SUBJECT: Lake Pontchartrain, La. and Vicinity, Florida Avenue Complex

TO C/Engineering Div

FROM A/E, New Orleans

Lake Pontchartrain, Louisiana and Vicinity
Florida Avenue Complex

BYPASS CHANNEL WEST IHNC

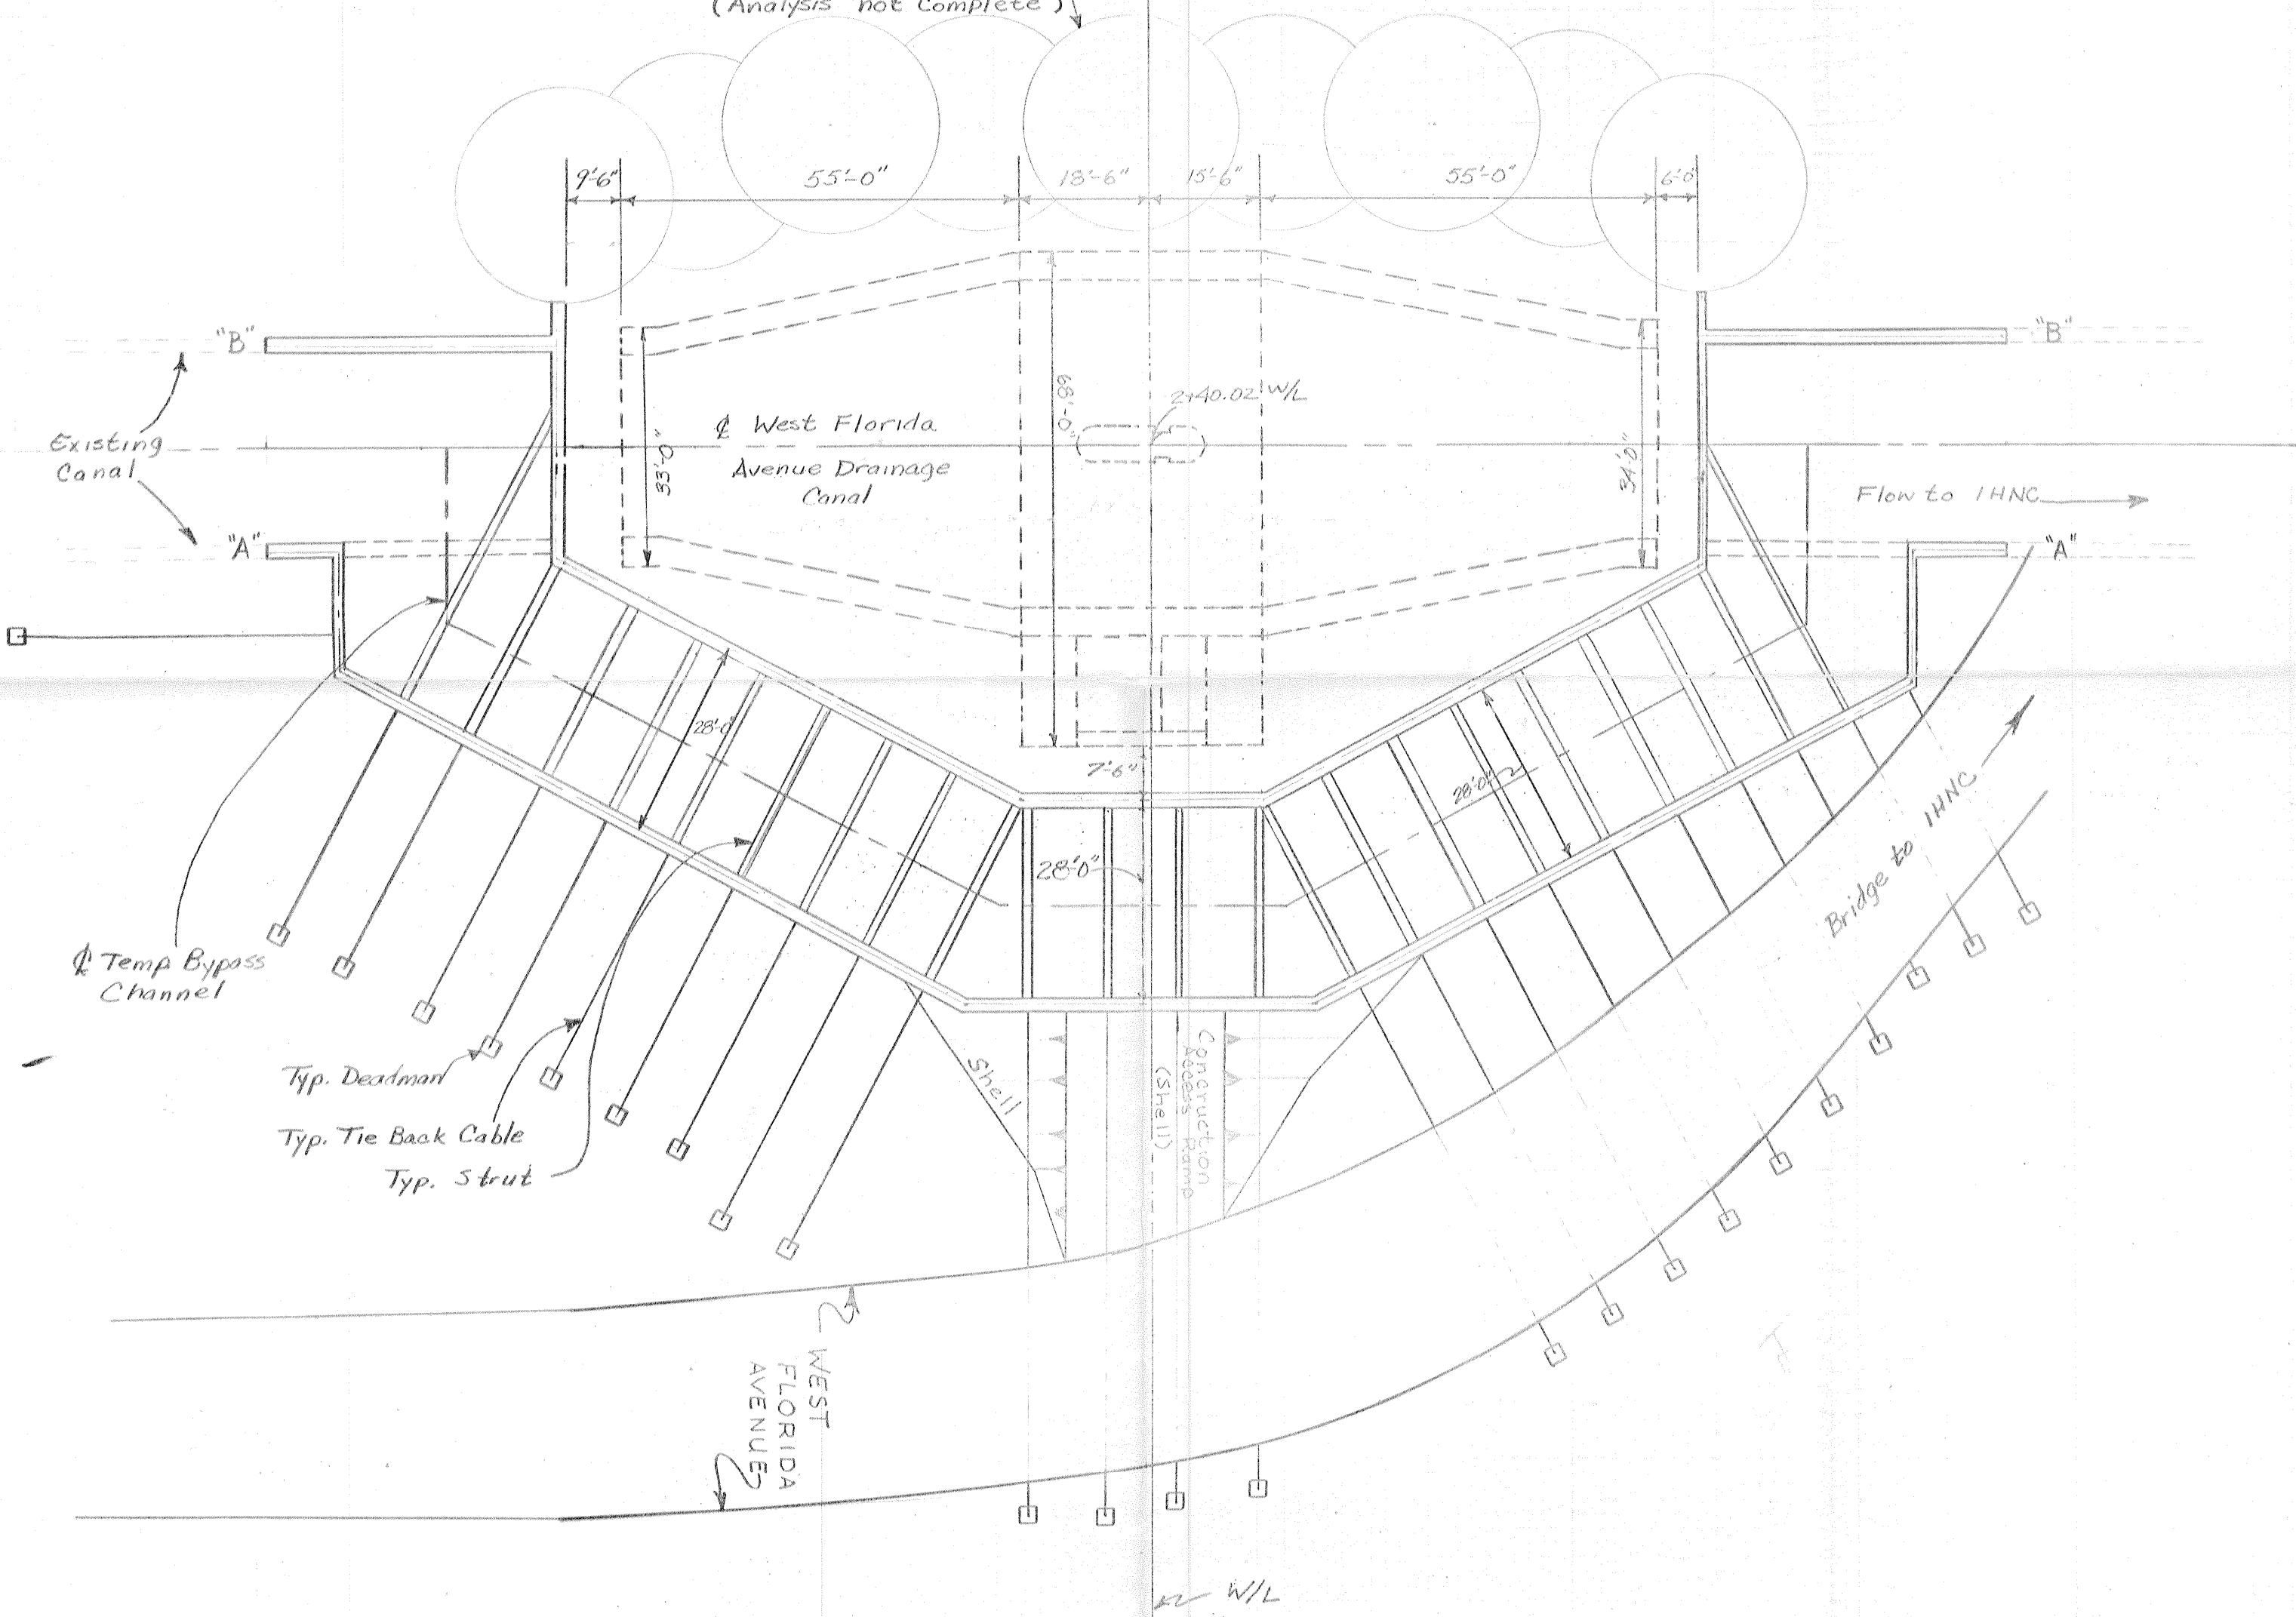
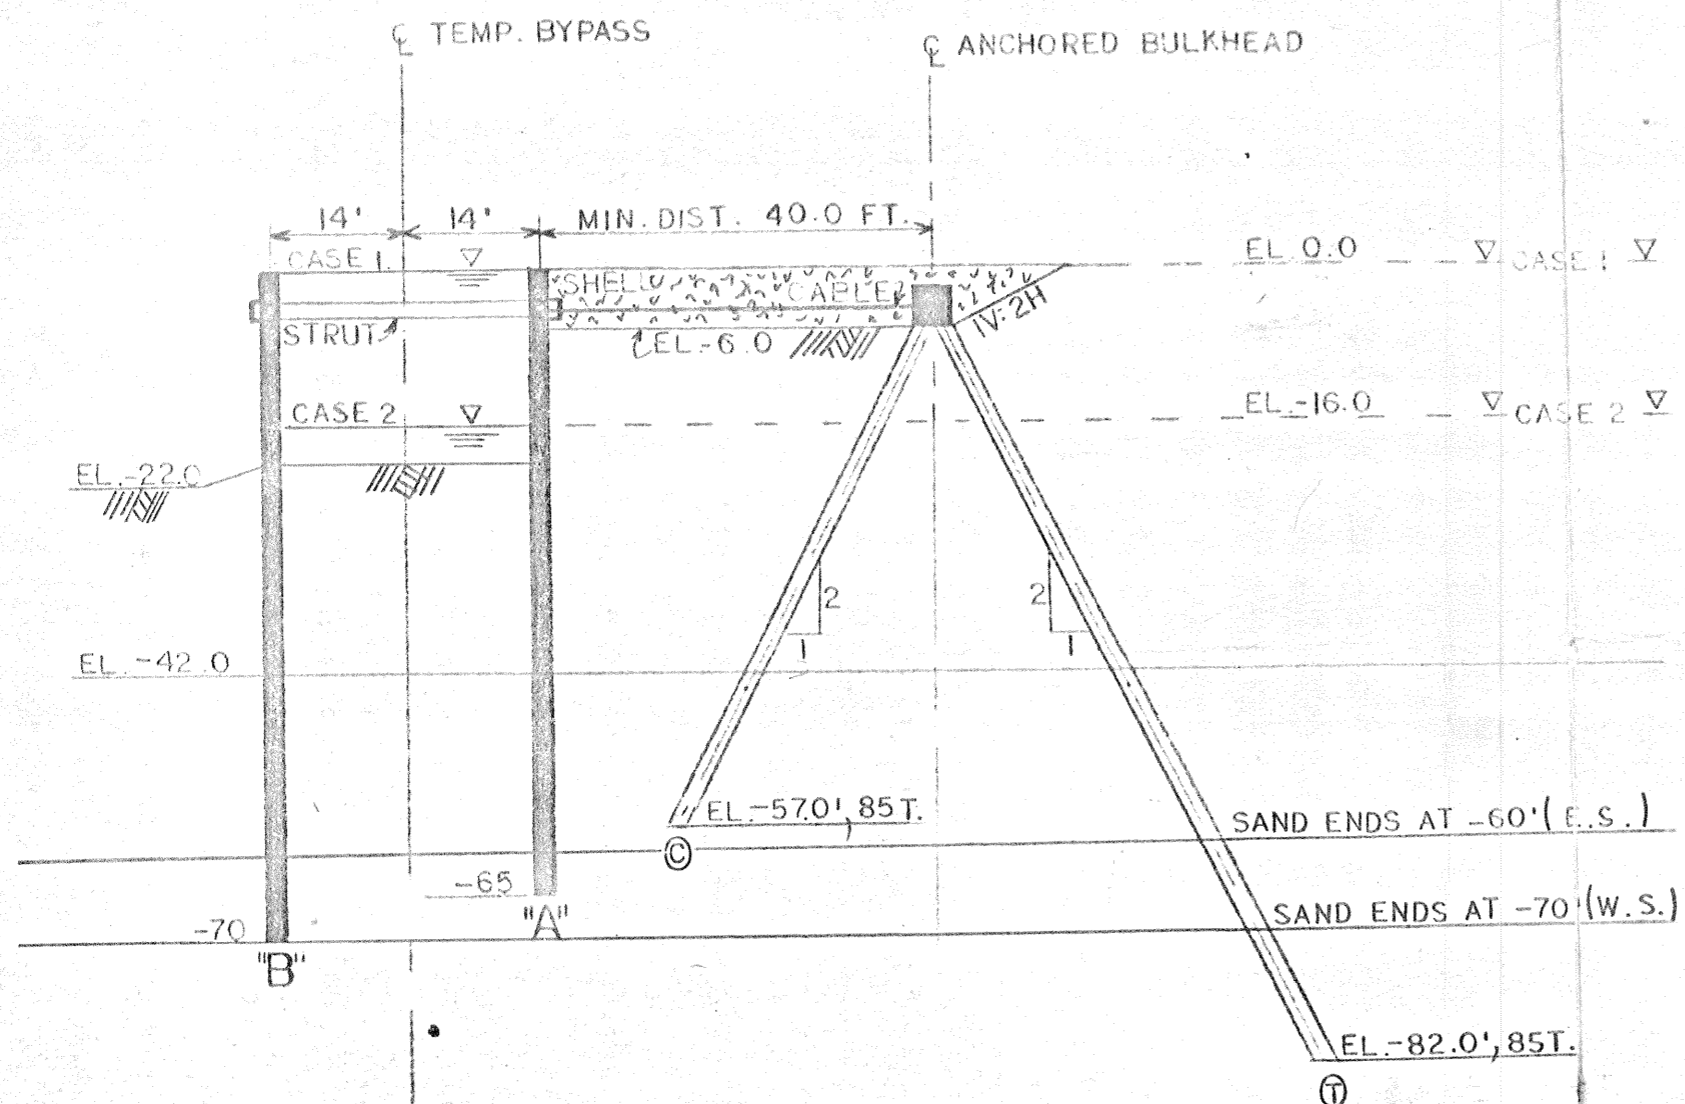
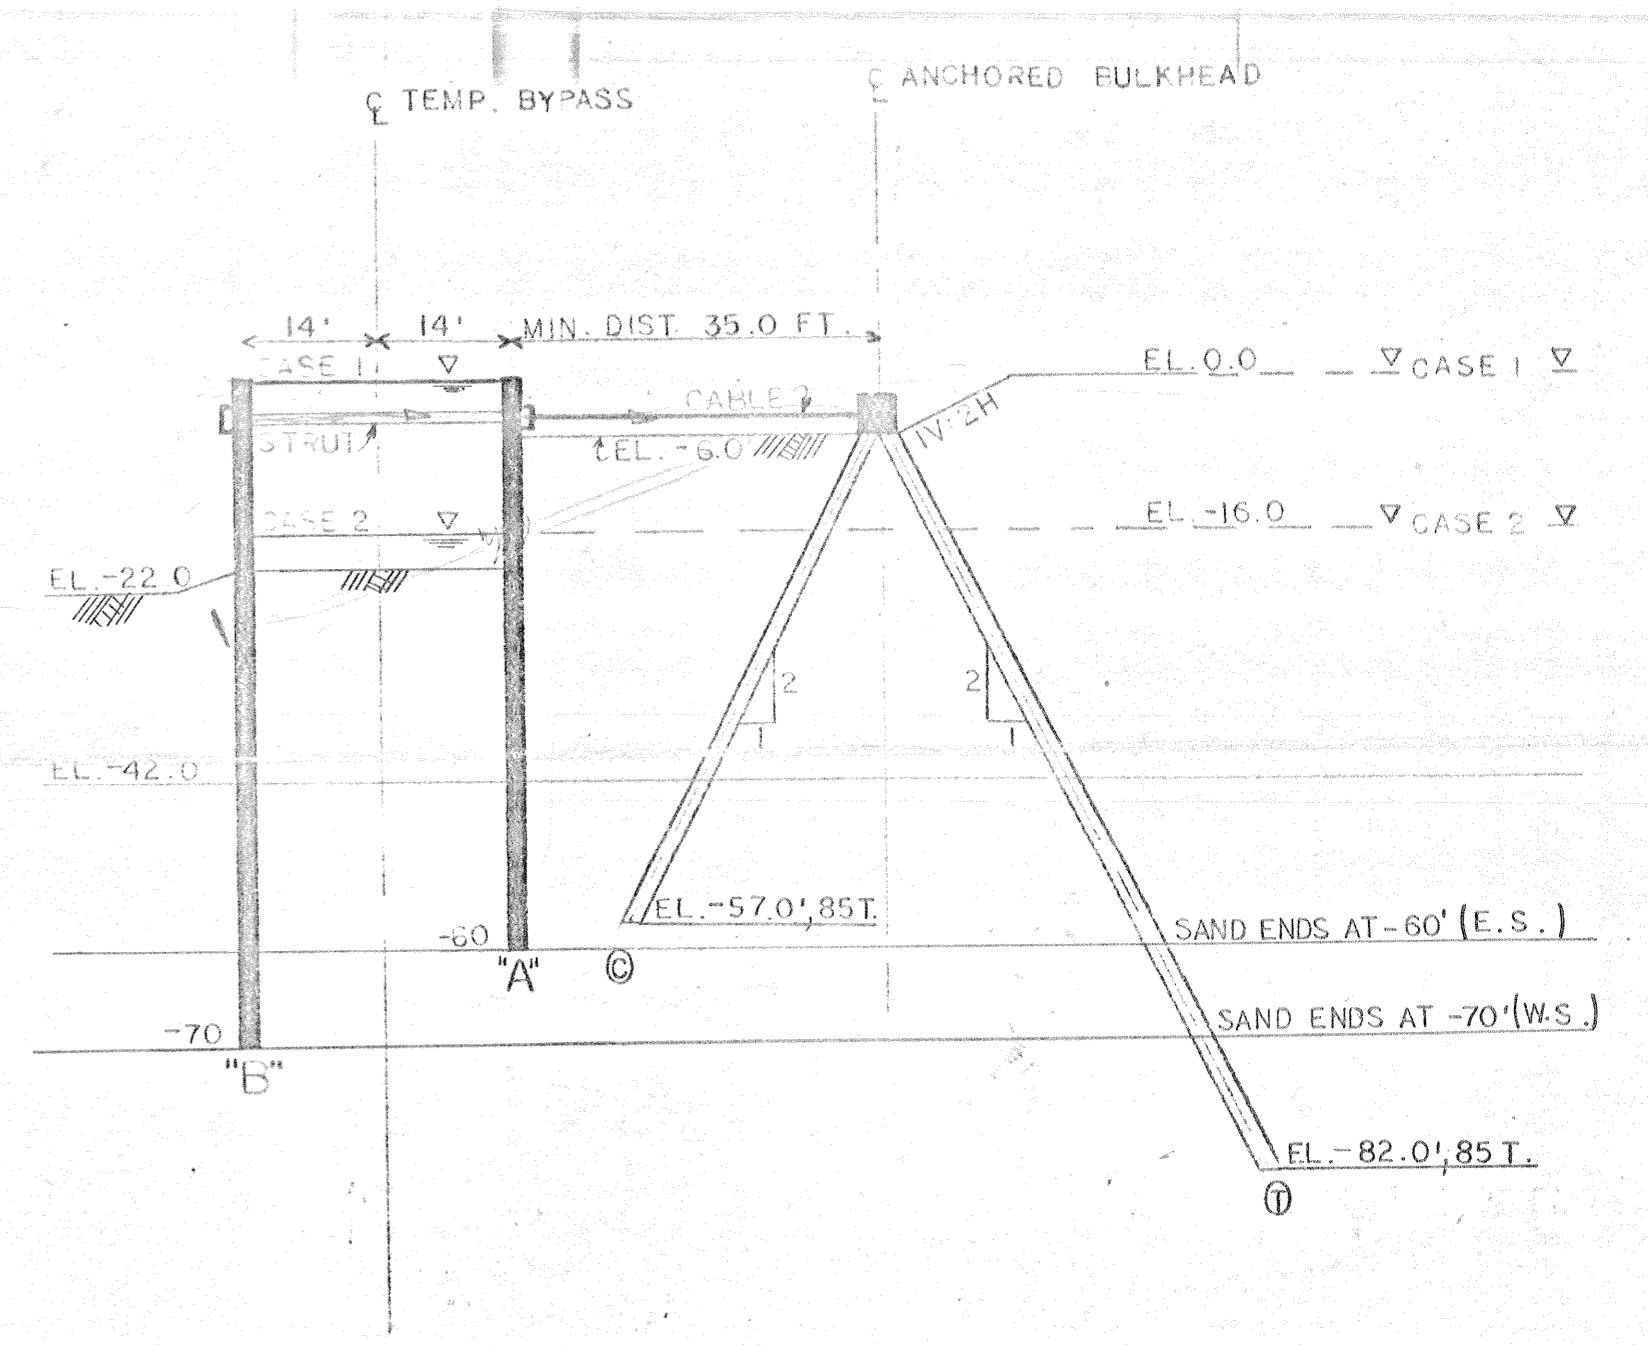
1. We have reviewed the plan of canal diversion by damming and reached the following conclusions. The daily canal flow of approximately 35 m.g.d. (55 c.f.s.) can be diverted around the vertical gate structure through 1-72" ϕ CMP with a head loss of 0.3 ft.

2. Inflows from the 4160 acres of drainage area (provided by the S&WB) were determined for the 1 yr - 24 hour storm and were floodrouted for different conditions. The stage in Florida Avenue would be 0.2 ft m.s.l. with 1-72" ϕ CMP and the top of the dam set at -5.0 ft m.s.l. It was determined that 8-72" ϕ CMP would be required to prevent the dam from being overtopped.

3. It was also determined that 0.8 inch or less per 24 hours of rainfall would not overtop the dam at -5.0 ft m.s.l. and with 1-72" ϕ CMP. The past 10 years of rainfall records at the London and Jourdan stations revealed that 0.8 inch or more of rainfall occurred 260 times during this period. Therefore, the dam will be overtopped approximately 26 times per year.
